Power Trim Manual Release Valve Tip Breakage – 35 thru 125

MARINER/ MERCURY SINGLE RAM POWER TRIM

Power Trim Date Code 13236 and Below

1989 thru 1995 35-125 h/p

Figure 1. Manual Release Valve Location

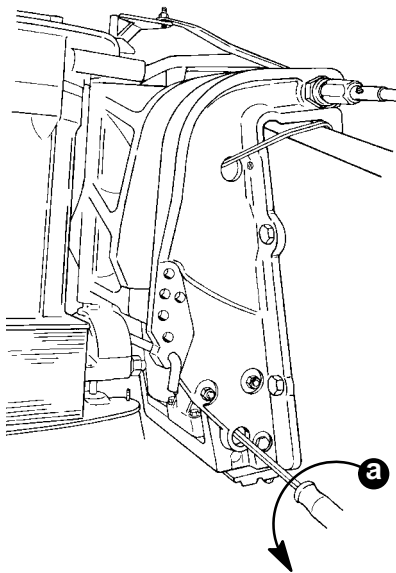
Single ram trim units that incorporate a **black** manual release valve, may have a tendency to break off the valve tip in the trim pump manifold assembly. The tip and o-ring usually remains lodged in the manifold assembly. Tip breakage is caused by a tight tolerance between the manual release valve and the manifold assembly bore.

The trim unit will not be able to be raised or lowered manually by unscrewing the manual release valve, three (3) turns maximum counterclockwise (Figure 1).
